# UNITED STATES PATENT AND TRADEMARK OFFICE

APPLICATION NO.	FILING DATE	FIRST NAMED INVENTOR	ATTORNEY DOCKET NO.	CONFIRMATION NO.
10/027,238	12/20/2001	John P. Sherwin	1238.17519	9086

**Office Action Summary**

**DETAILED ACTION**

**Exhibit A****Conclusion**

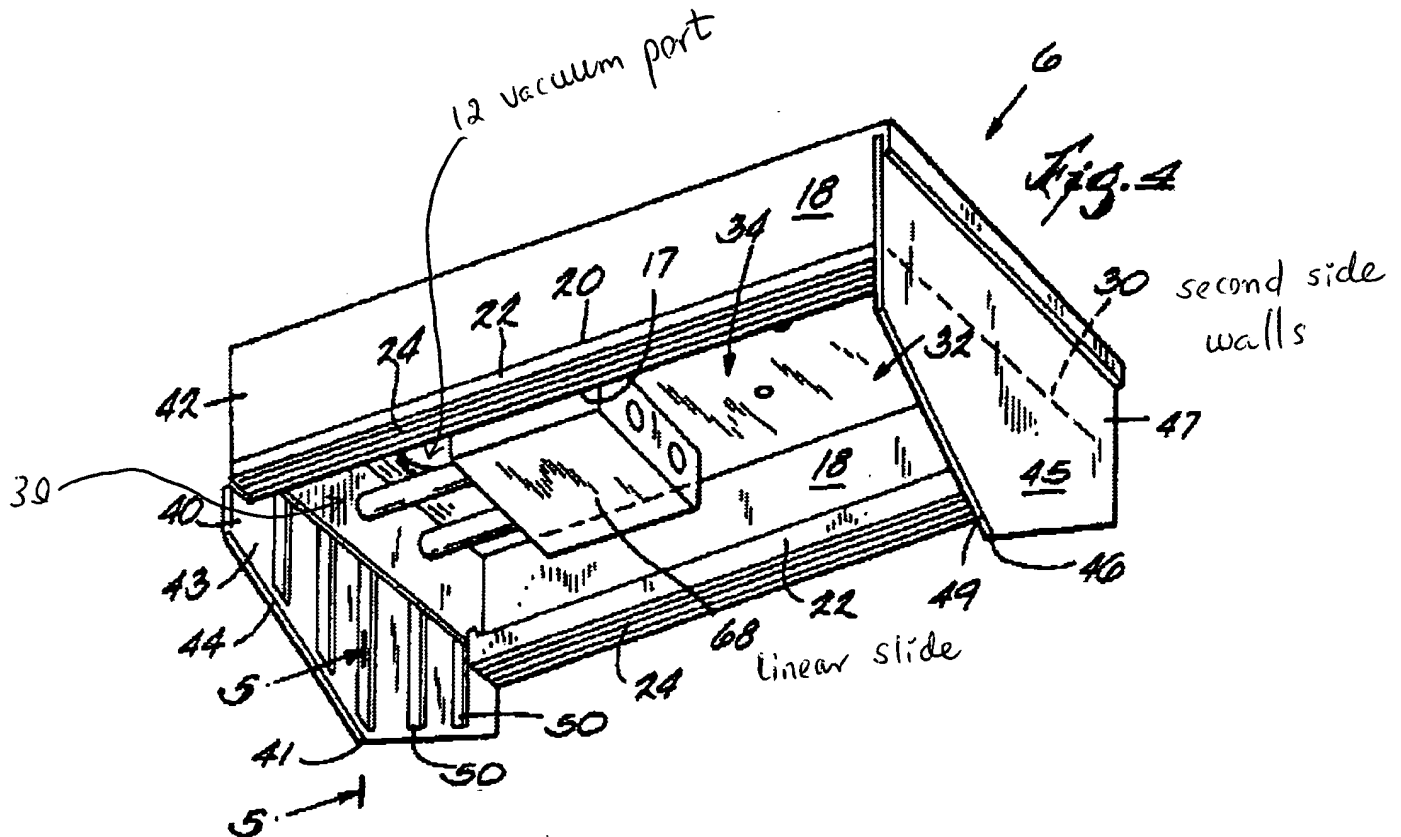
Applicant argues that Holter's device does not show "the gripping surface being located outboard of the surround." First of all, the word "outboard" is defined as "*Nautical. Situated or positioned outside the hull of a vessel. b. Being in a position that is away from the center line of the hull of a ship; or Situated or positioned toward or nearer the end of a wing of an aircraft*" according to *The American Heritage® Dictionary of the English Language, Third Edition* copyright © 1992. Therefore, it is pointed out that the first and second gripping elements (40,45) having smooth surfaces (inside and outside surfaces on each blade) are being located outboard (situated or positioned outside or situated or positioned toward or nearer) the surround (18,18,30,30) (see Fig. 4). The prior art discloses a surround including a pair of first side walls (18,18) (see **Exhibit A** (next page) from Fig. 4, and Col 3, lines 42-49) and a pair of second side walls (30,30) (see *dotted lines* in Figs. 3 and 4, and Col 3, lines 54-60) mounted on the base plate (10) wherein the first and second gripping elements (40,45) having smooth surfaces (both inside and outside surfaces on each blade) are located outboard situated or positioned outside or situated or positioned toward or nearer) of the surround (18,18,30,30) (Col 4, lines 12-23).

Moreover, applicant argues that the newly presented limitation of claim 1 ("first and second gripping elements are arranged separately and independently from the vacuum port") is patentably distinguishes from the prior art. The argument is not persuasive because the prior art meets the limitation. Holter's gripper (5,727,832) shows that the first and second gripping elements (40,45) being arranged separately and independently from the vacuum port (12) (see Fig. 4). It is pointed out that the gripping element (40) is being movably coupled a linear slide (68) and being operated separately and independently from the vacuum port (12) wherein the

gripping element is independently and separately movably mounted and the vacuum port (12) is permanently fixed in the plate (10) (see Exhibit A below).
